Re:- Plot No. 18, K.P.C.E. Society.

3-1
2Plot No. 18 K.P.H. Soc. Sheet No. Cantonment Qr.

PLAN SHOWING ADDITIONS & ALTERATIONS
IN DUNGALOW ON PLOT NO 18.
KARACHI PARSİ CO-OPERATIVE HOUSING SOCIETY

FRONT ELEVATION

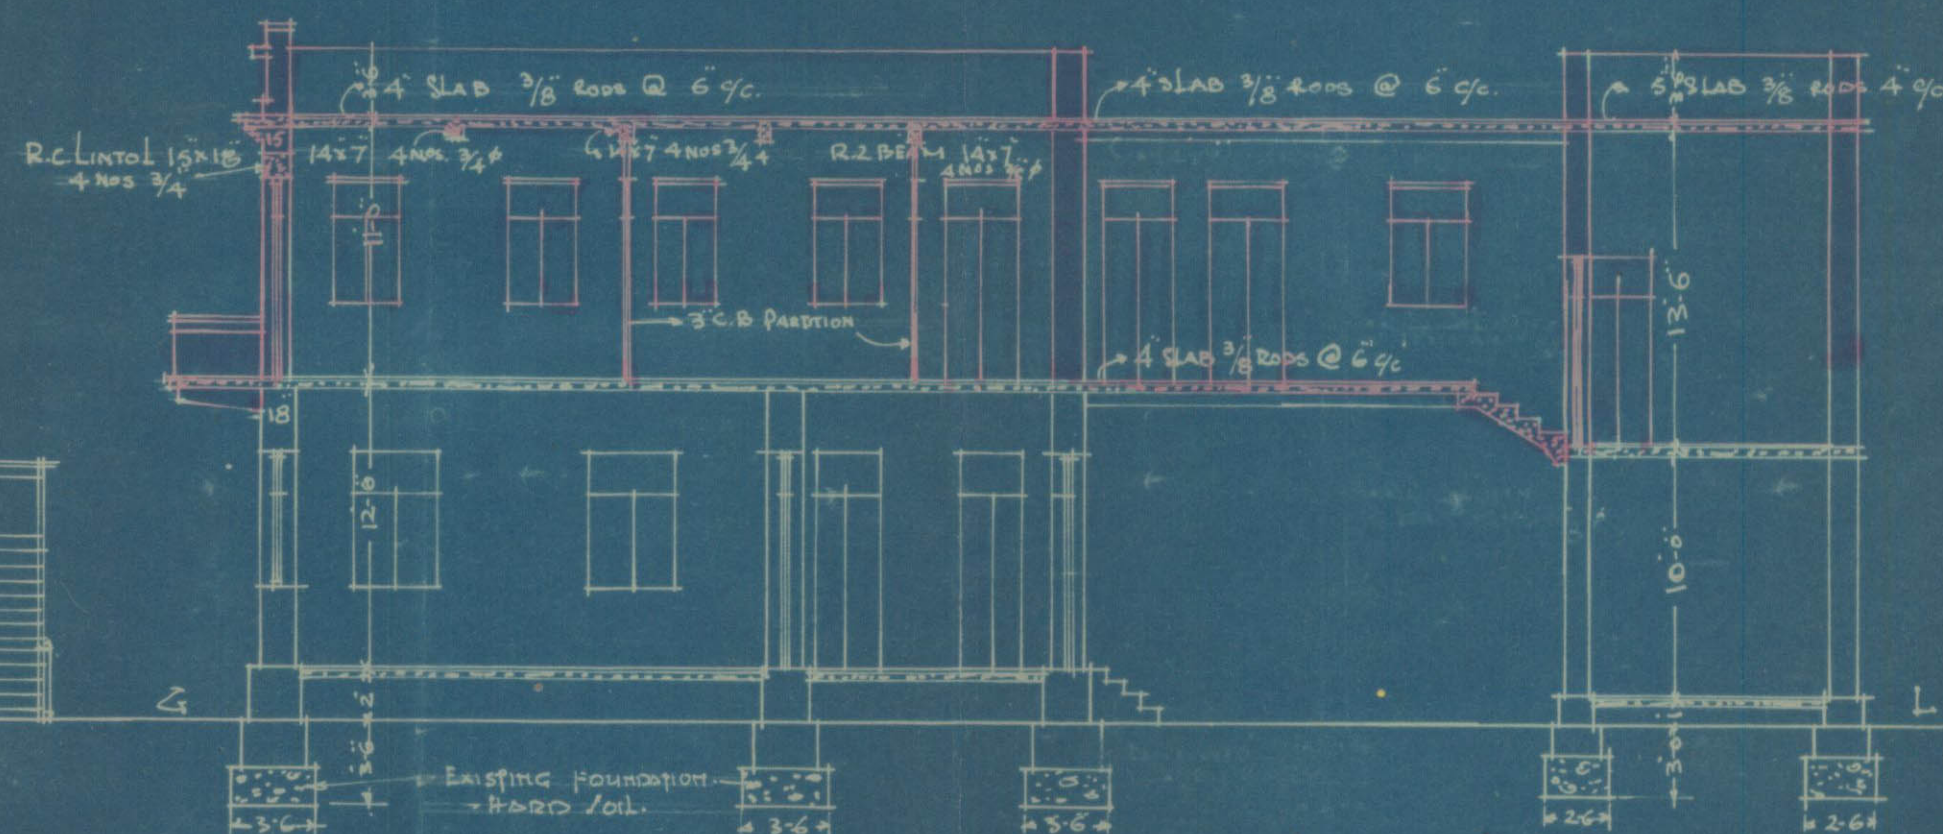
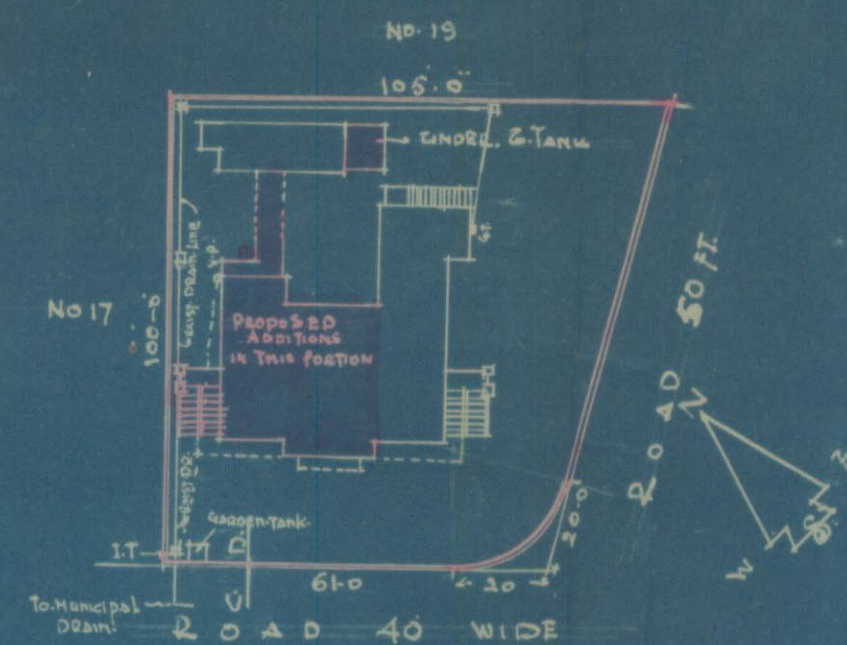
(1) What do the dotted lines behind the staircases
show? If they are eaves they should be shown
in elevation.

* Submitted. The objections have now been complied
with. There is no objection to the plans now

SECTION ON LINE A-B.

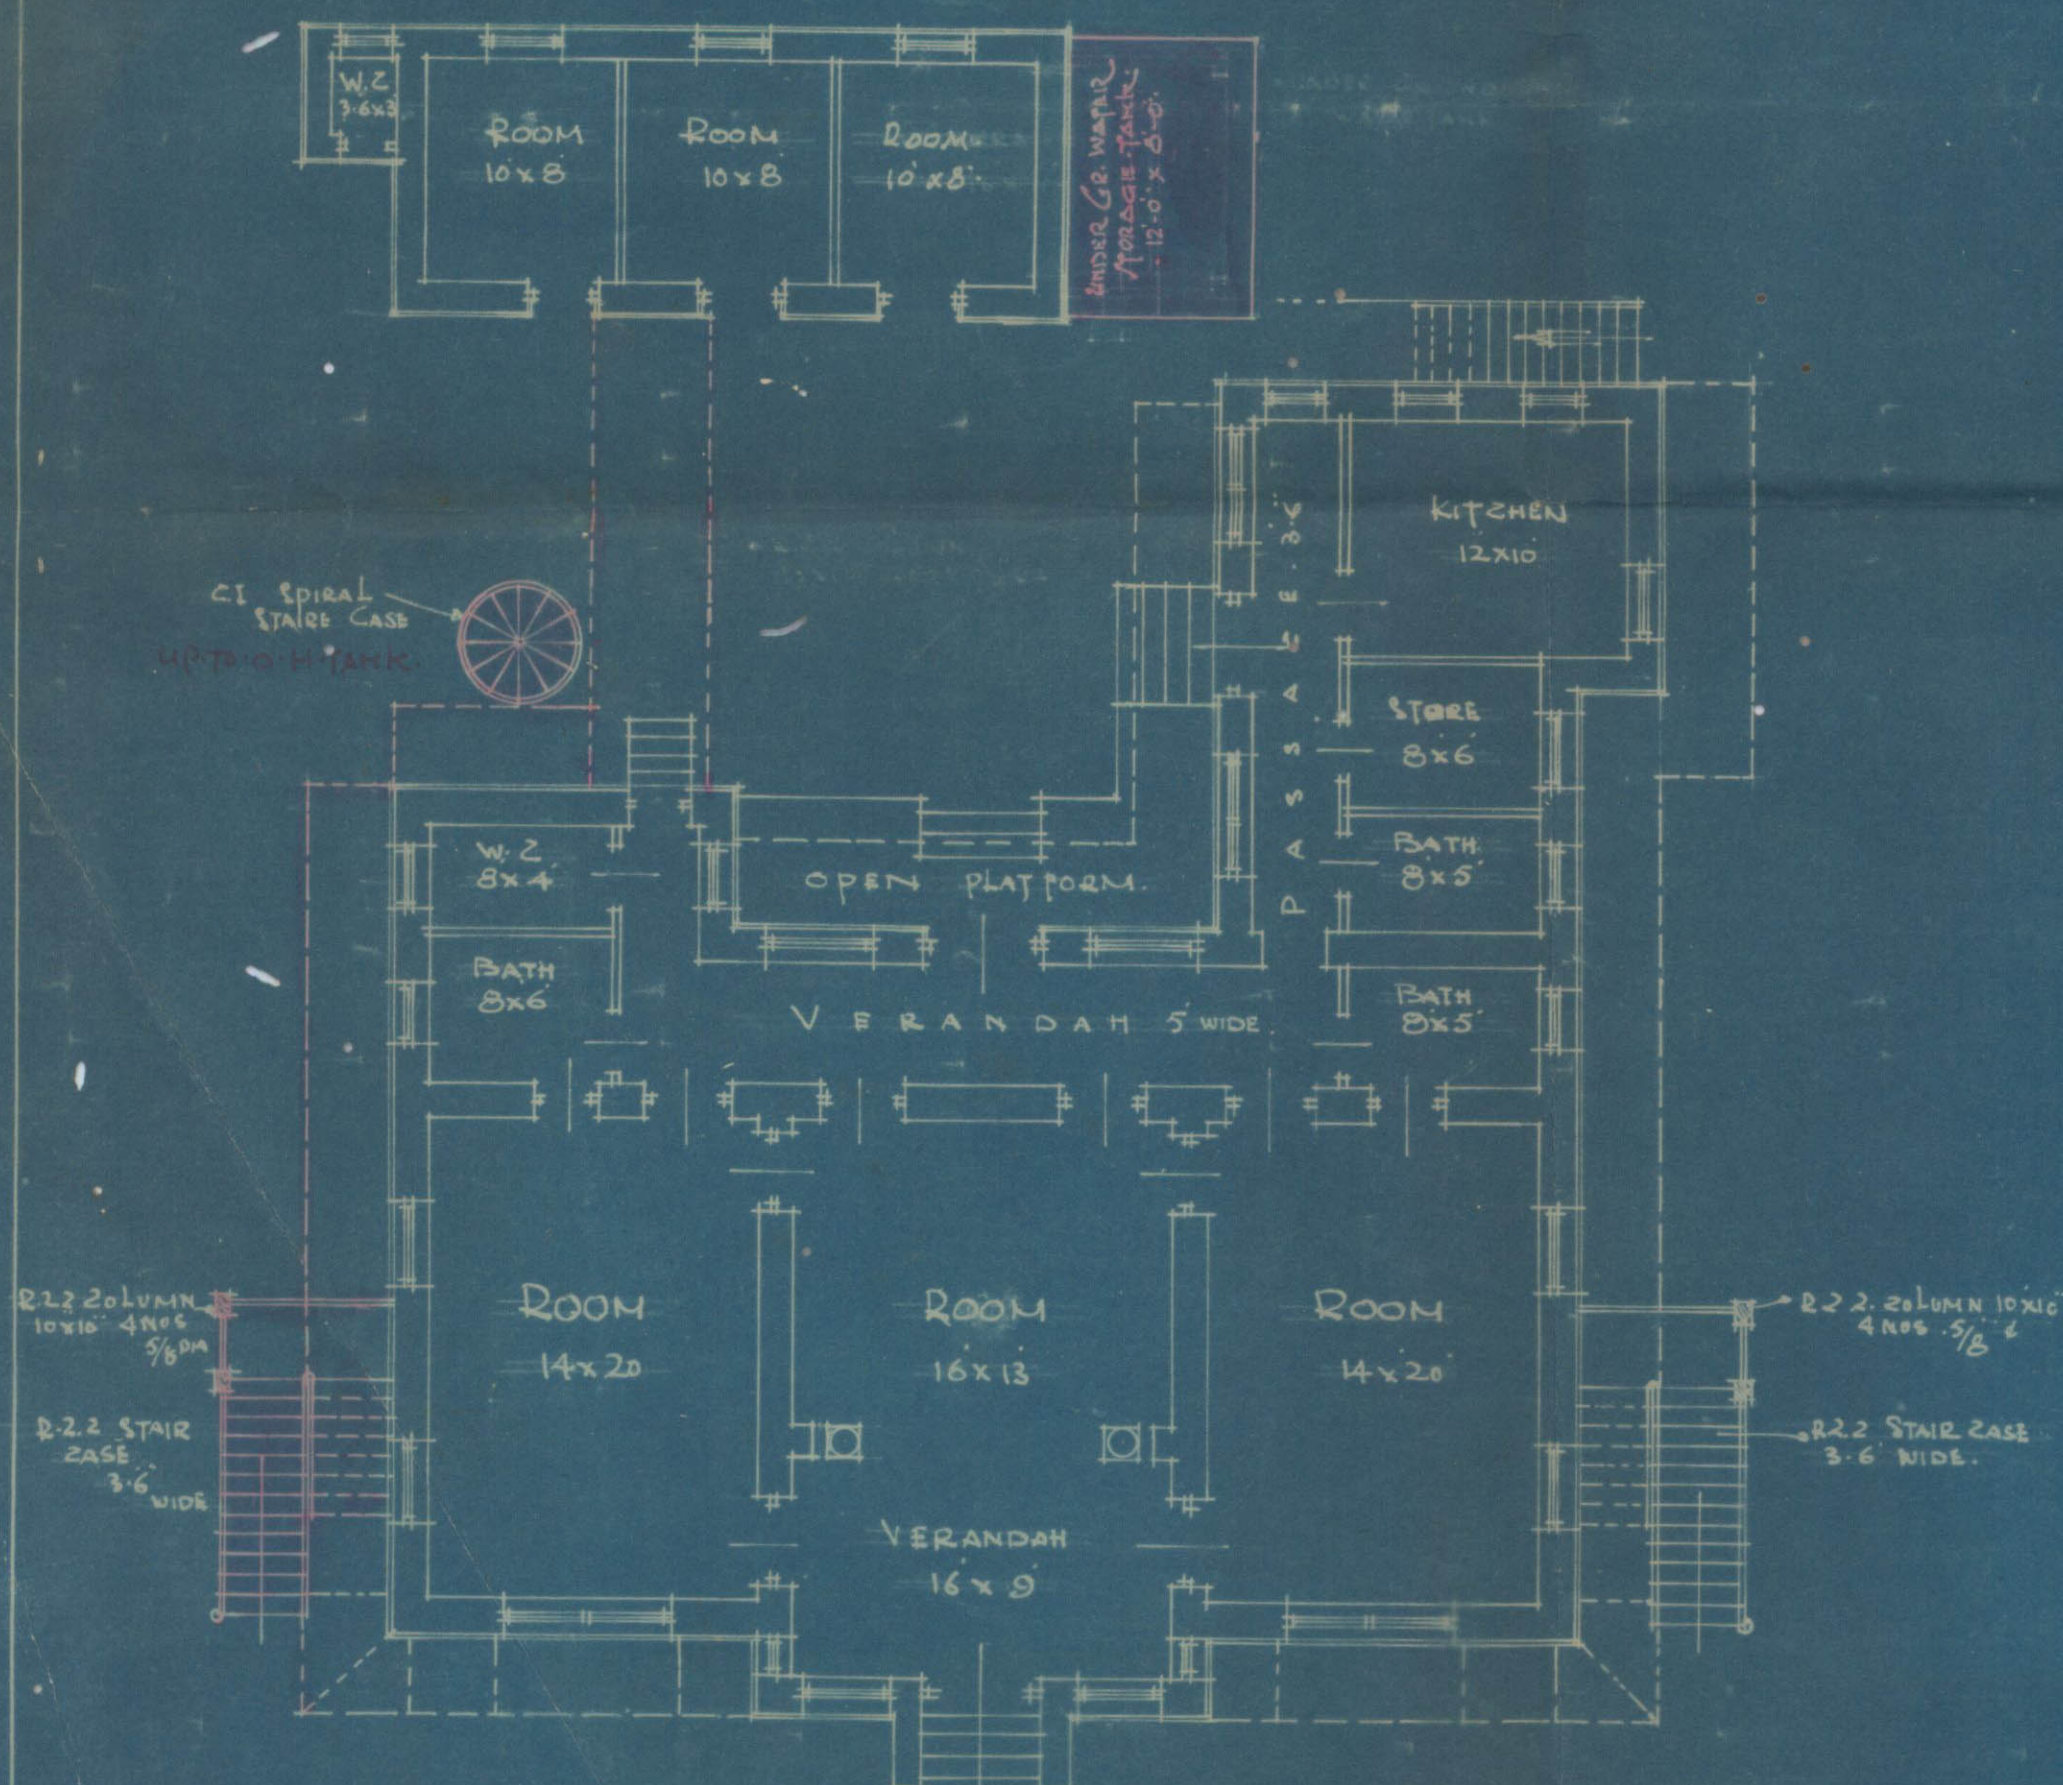
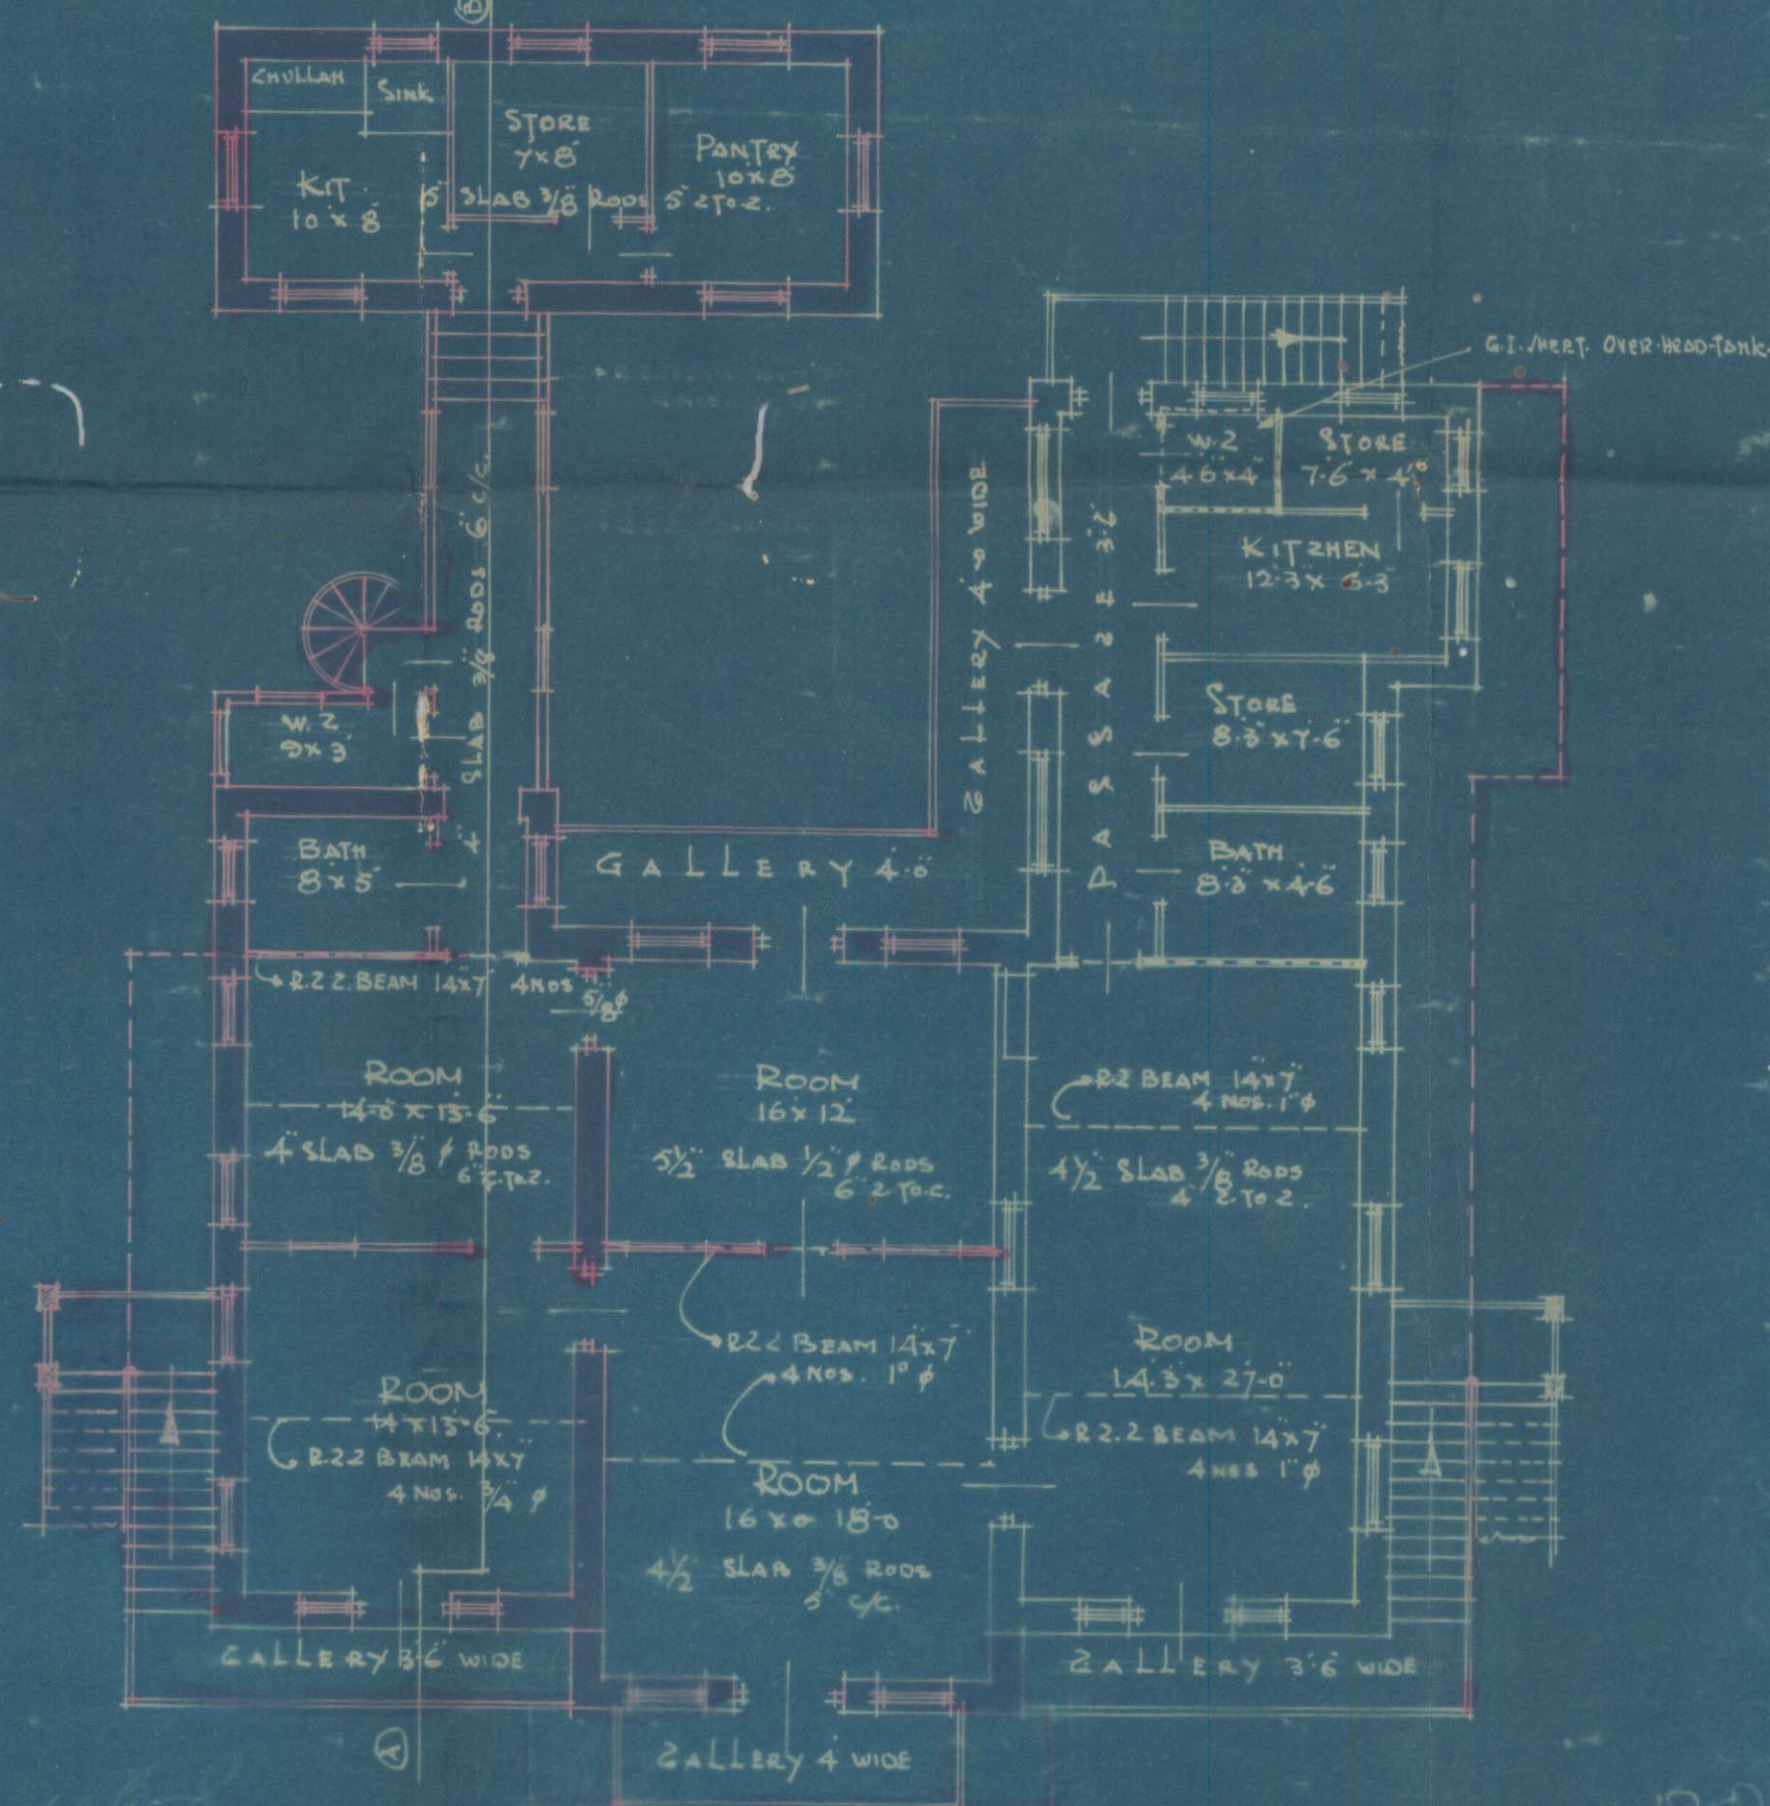
1. Access to the O. H. tank be provided.

No objection to the plan as
corrected: *[Signature]* 6/1
Asst. Eng.
